**UNITED STATES OF AMERICA
NUCLEAR REGULATORY COMMISSION**

In the Matter of)	
)	
Dominion Virginia Power)	Docket No. 52-017-COL
)	
North Anna Power Station, Unit 3)

**DOMINION VIRGINIA POWER'S
RESPONSES TO PRE-HEARING QUESTIONS**

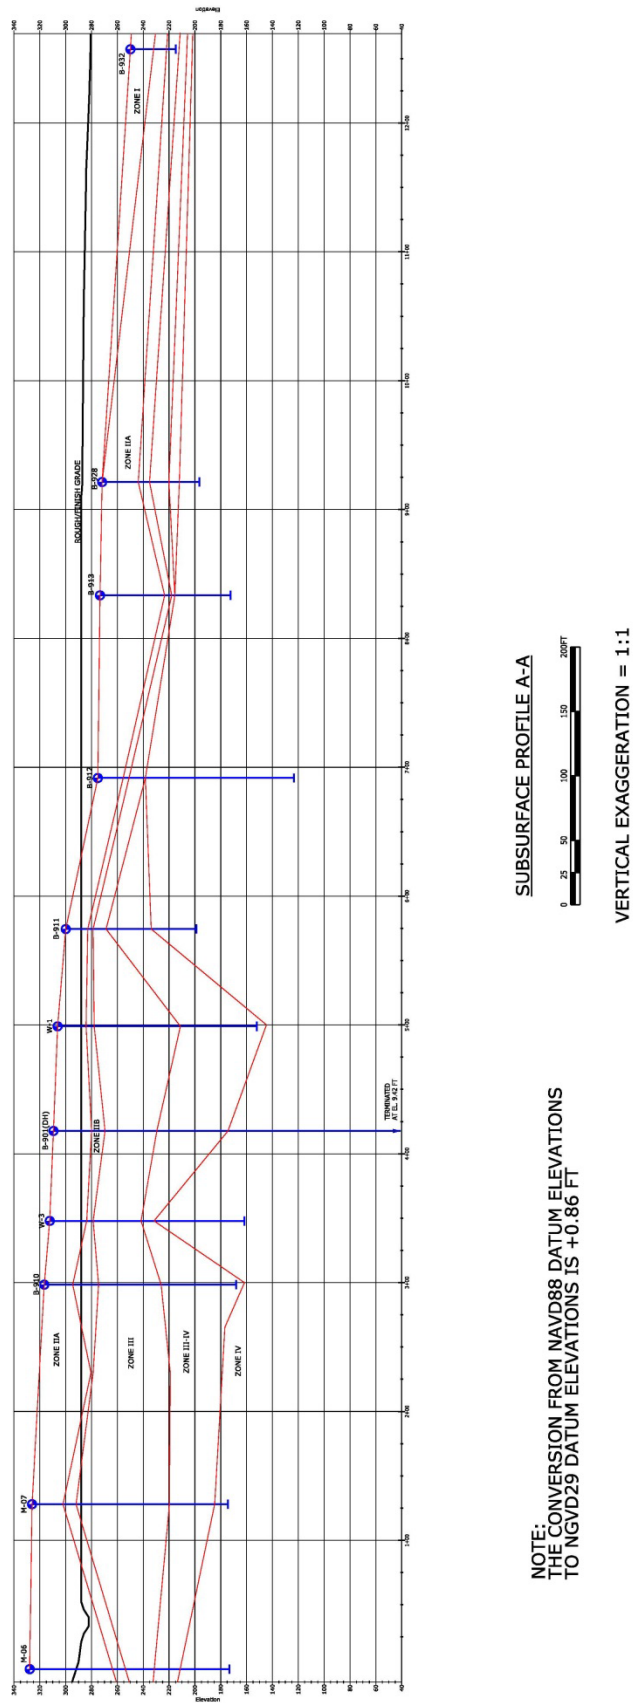
Question 1: In Request for Additional Information 5693, 2.5.2-3a, dated May 5, 2011 (ML11125A124), the Staff asked the Applicant to justify the one-dimensional (1D) site response analysis using only vertically propagating shear waves, given the complex topography of the subsurface layers. On August 25, 2011 (ML11241A058), the Applicant responded that the soil and rocks at the site are all derived from the same parent rock. The Applicant attributed the subsurface variability to the localized effects of weathering on minerals comprising the parent rock rather than to deposition of soil as distinct layers. For lateral variability, the Applicant states that the boundaries between rock types are gradational and so do not represent lateral impedance boundaries that may result in refraction, reflection, or trapping of the shear waves traveling in horizontal directions. Therefore, the site can be characterized as undulating, but not *dipping*, thus justifying the 1D analysis. The Applicant uses the same weathering process to explain the existence of vertical variation, but with distinct boundary impedances at different depths as shown in Final Safety Evaluation Report (FSER) Figure 2.5.2-5. Please discuss why the same weathering mechanism generates sharp boundaries vertically, but not laterally.

Weathering, the process of breaking rock down to soil, has probably been active during the past tens of millions of years, since regional uplift of the Piedmont Province. The weathering process starts from the surface and progresses vertically downwards – it can be physical, chemical or biological. Physical weathering is caused by processes such as freezing and thawing, wetting and drying, and shrinking and swelling. In chemical weathering, the rock decomposes through a series of chemical processes such as dissolution, oxidation and acidification. Biological weathering is most commonly characterized by the effects of tree and plant roots.

The end product of rock weathering depends on the composition of the rock and the weathering processes. The various stages of the weathering in place of the North Anna bedrock can be seen in Figure Q1-1 (FSER Figure 2.5.4-1 modified to remove the vertical scale exaggeration). The sound bedrock (Zone IV) degrades to slightly-to-moderately weathered rock (Zone III-IV), then weathered rock (Zone III), then saprolite (Zones IIA and IIB) which is mainly granular soil that still exhibits the structure of the bedrock, and finally clay soil (Zone I) which contains no relict bedrock structure and is now mostly absent from the site. Because of the vertical progression of the weathering process, these zones are nominally horizontal. Some random lateral variation (as seen in Figure Q1-1) occurs because the weathering processes are not always uniform, and the rock is not entirely homogeneous. It should be noted that the zone separations depicted on the figure are made by joining the zone boundaries in the borings by straight lines for simplification

– in reality these changes will be a gradual transition (similar to the ground surface) and thus the description of “undulating.”
